1. Response to Reasons for Refusal – Traffic and Transport

Following submission of the Development Application (DA-1182/2024) for the redevelopment of the Altis Compass Centre in Bankstown, Canterbury Bankstown City Council (CBCC) have recommended refusal of the application.

PROJECT
BANKSTOWN COMPASS
CENTRE

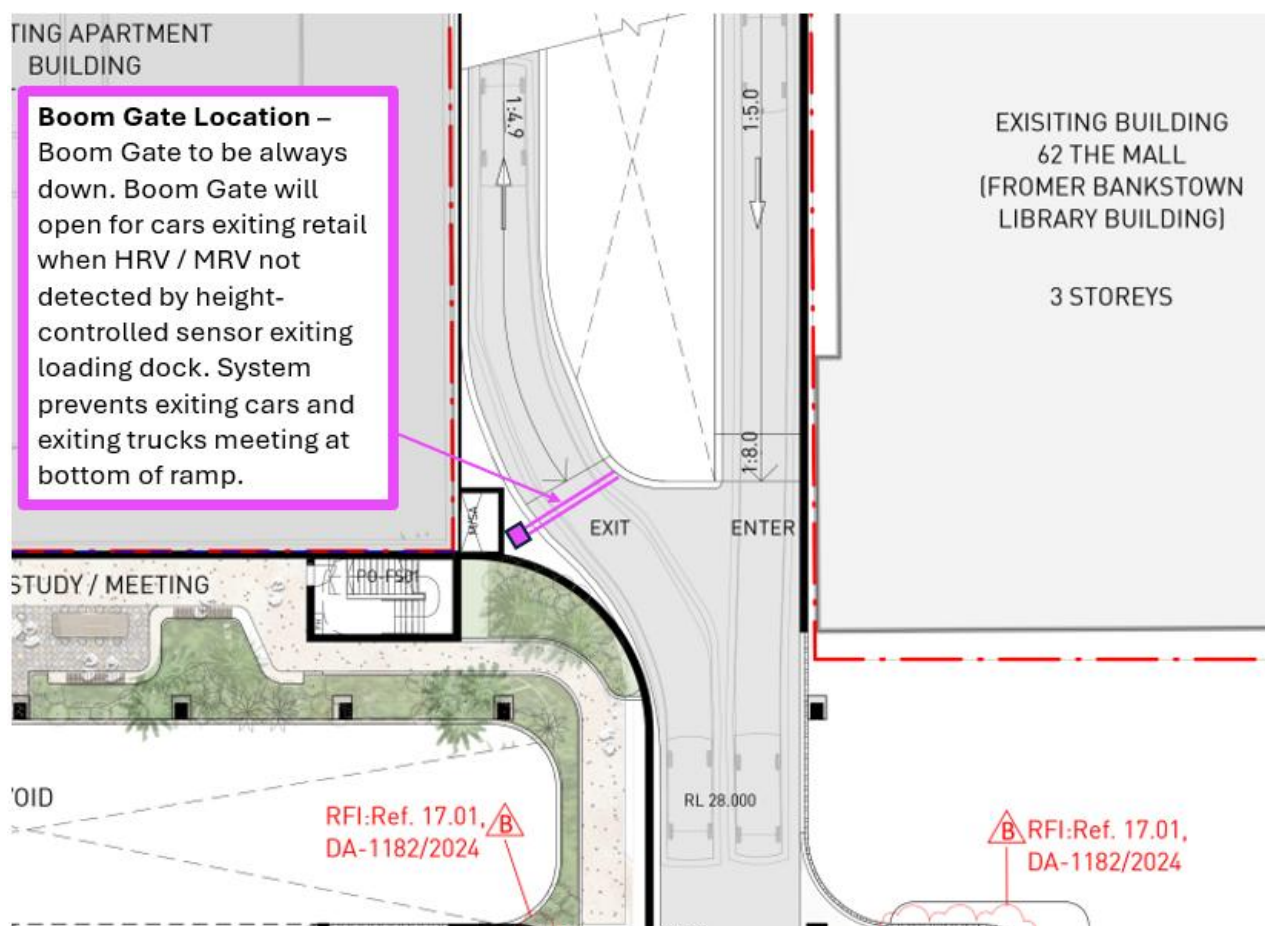
Royal Randwick Shopping Centre opened in 1990, while this has been historically approved, it should not set a precedence for a non-compliant future access arrangement. This outdated, unsafe and non-compliant arrangement should not be used as a basis for new development. Creating narrower and non-compliant driveways where there is conflict with heavy and light vehicles as well as pedestrians further compromises safety for all road users.

Royal Randwick Shopping Centre was presented as an example, working within a constrained location, which Council acknowledges has been open and operating since 1990. **ptc.** would request justification from Council that this arrangement is 'unsafe' given its operation for circa 35 years. It should also be noted that Royal

Randwick Shopping Centre is accessed directly from Avoca Street, which has much higher traffic flows than the future lightly trafficked arrangement for Fetherstone Street.

DRAWING # PTC - 001

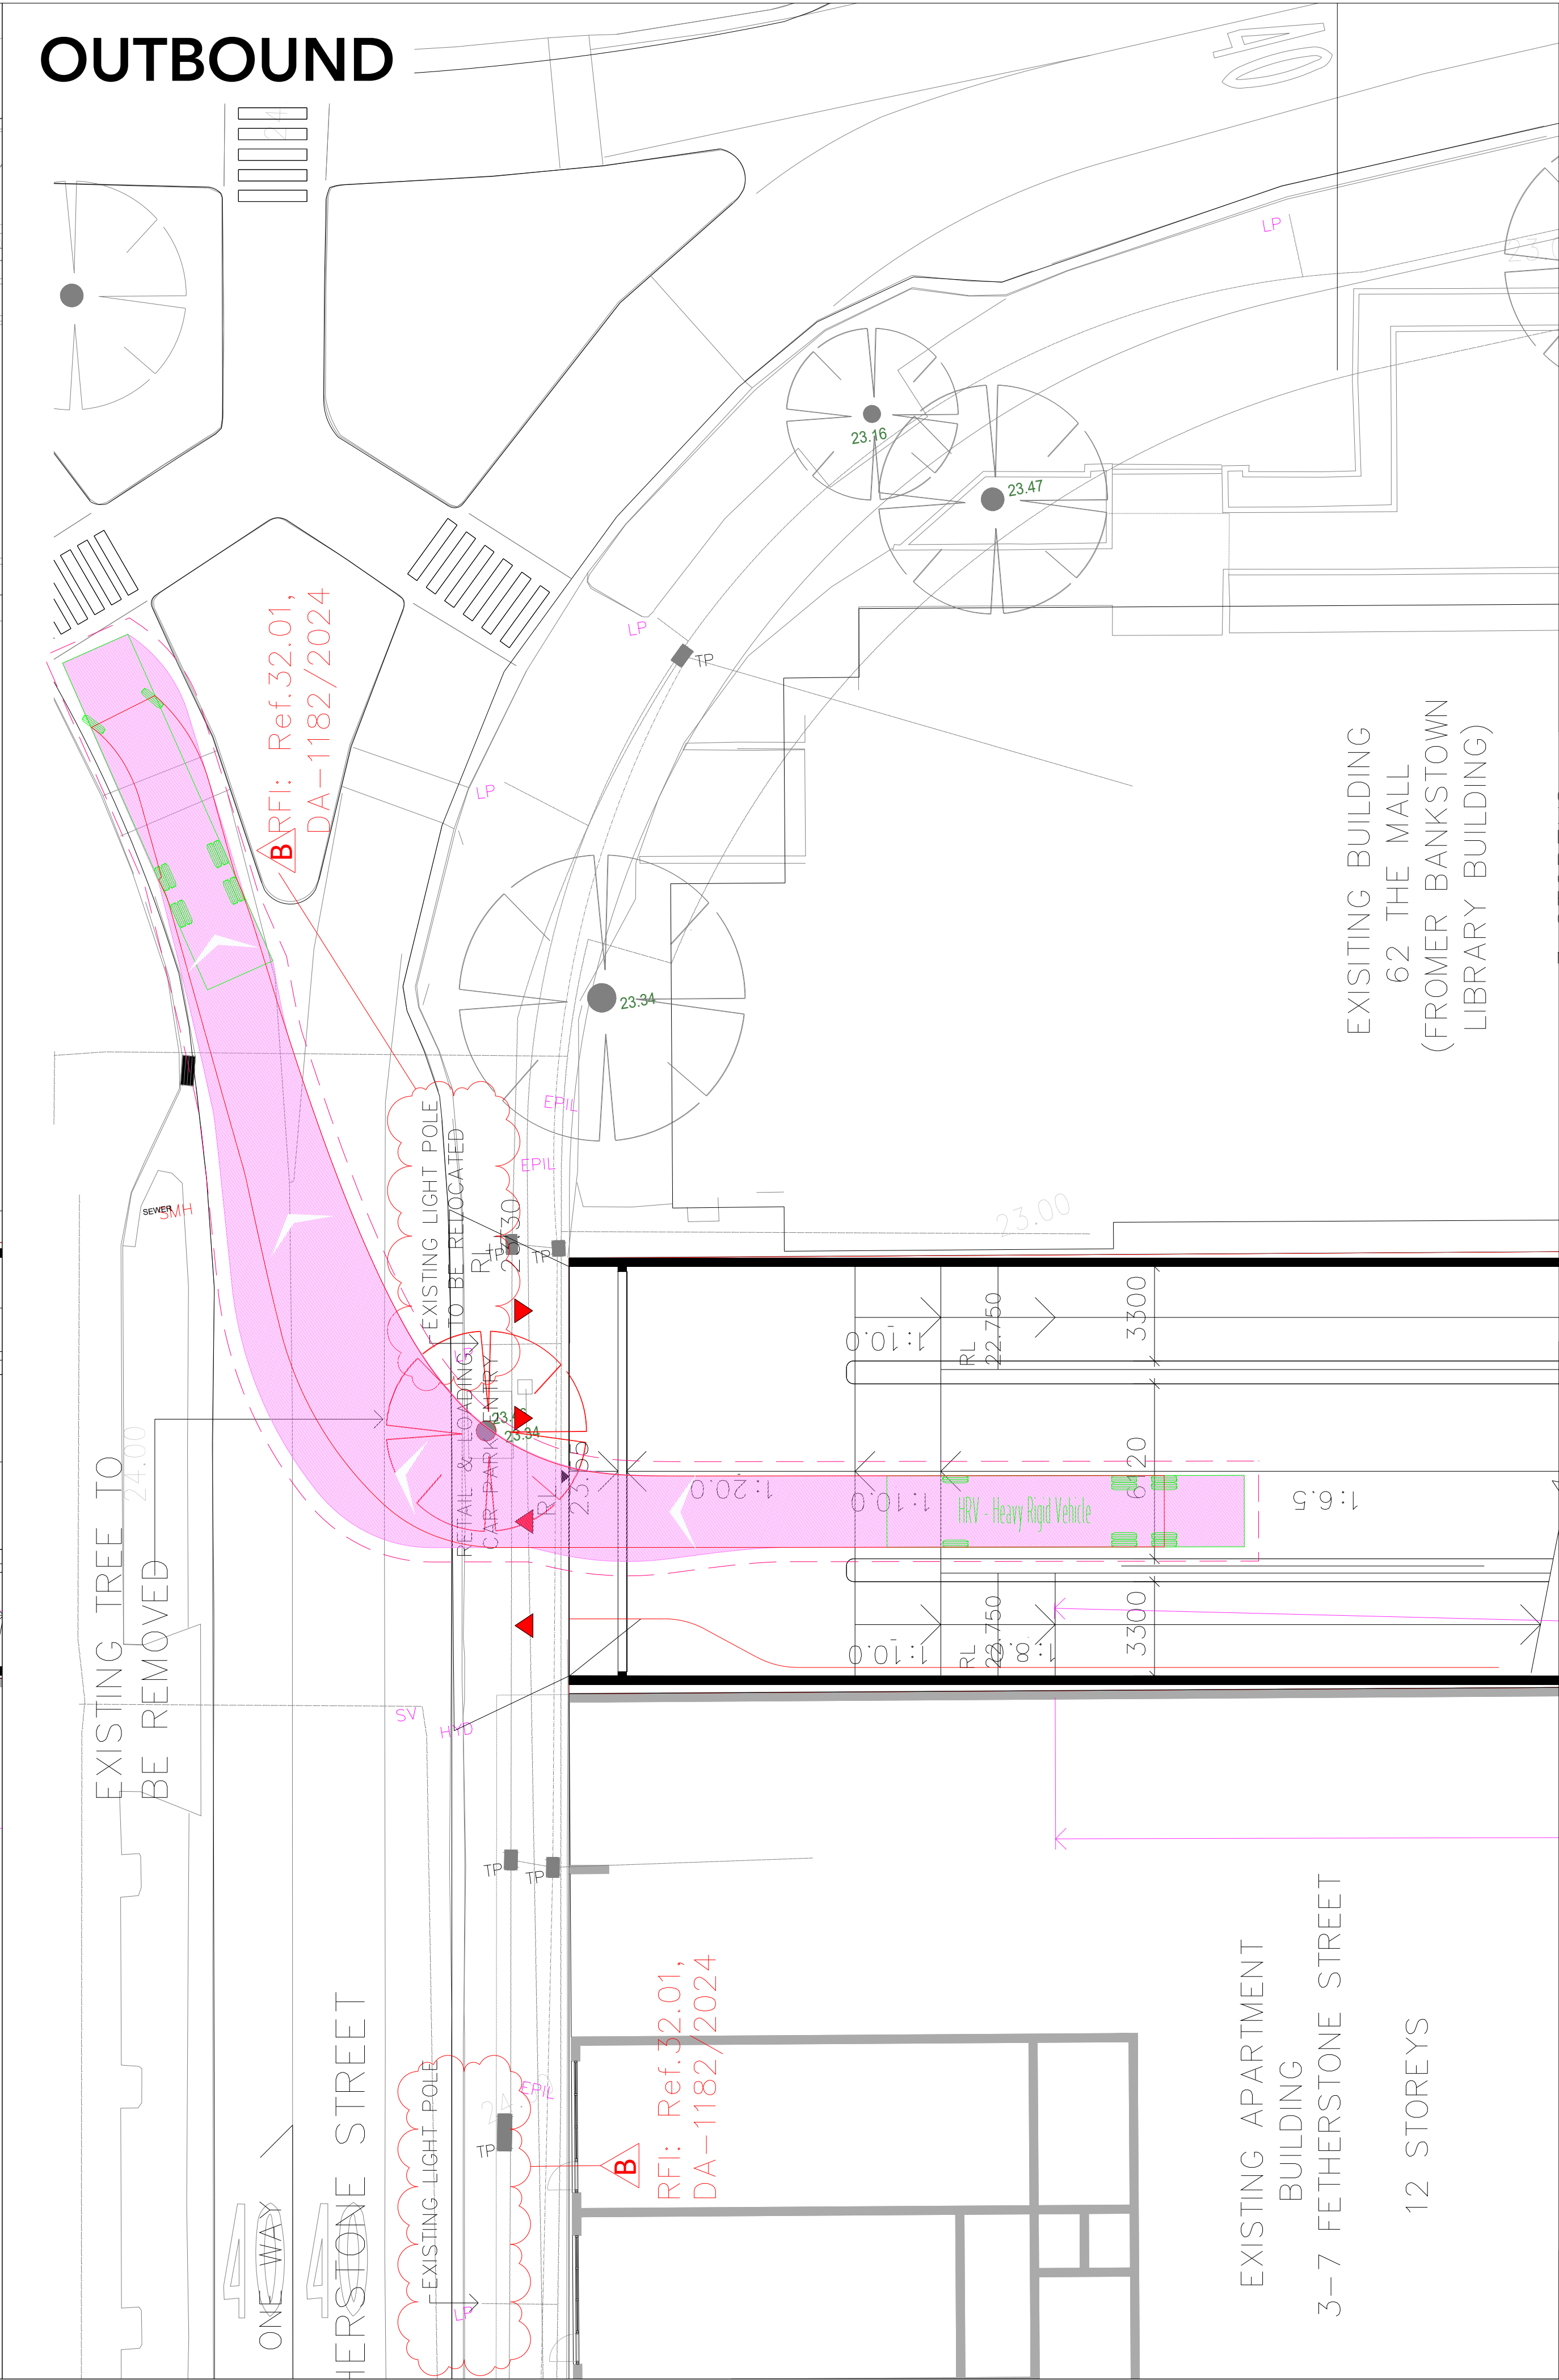
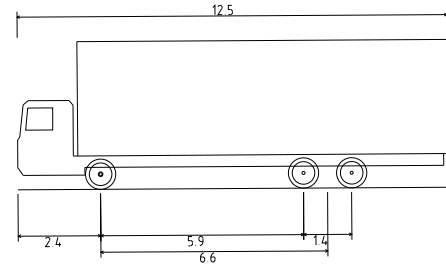
Further consideration of the potential traffic efficiency and pedestrian safety impacts of the proposed site access arrangements is required. Swept path analysis reflecting the street's future configuration should also be provided.

The direction of the swept paths do not reflect the current direction of traffic which is one way northbound.

Swept path analysis has been provided within the submitted Traffic Impact Assessment (TIA) that demonstrated vehicles entering and exiting from the north as per the Complete Streets configuration, noting that Fetherstone Street is currently one-way northbound. For completeness, swept path analysis for the largest vehicle requiring access to the site (HRV – Council Waste Collection) for both the existing (dwg PTC-001a) and future Complete Streets configuration (dwg PTC-001) of Fetherstone Street is contained as Annex A.

The swept path analysis has been completed based on the future scenario whereby cars and trucks would enter and exit the site from the North. Annex A presents both scenarios for ease.

A detailed response will be prepared by the Waste Consultant, however, for information swept path analysis demonstrating that a HRV can enter and exit the site in a forward gear is presented within Annex A. Drawings prepared by PTW demonstrate that 4.5m vertical clearance can be achieved.
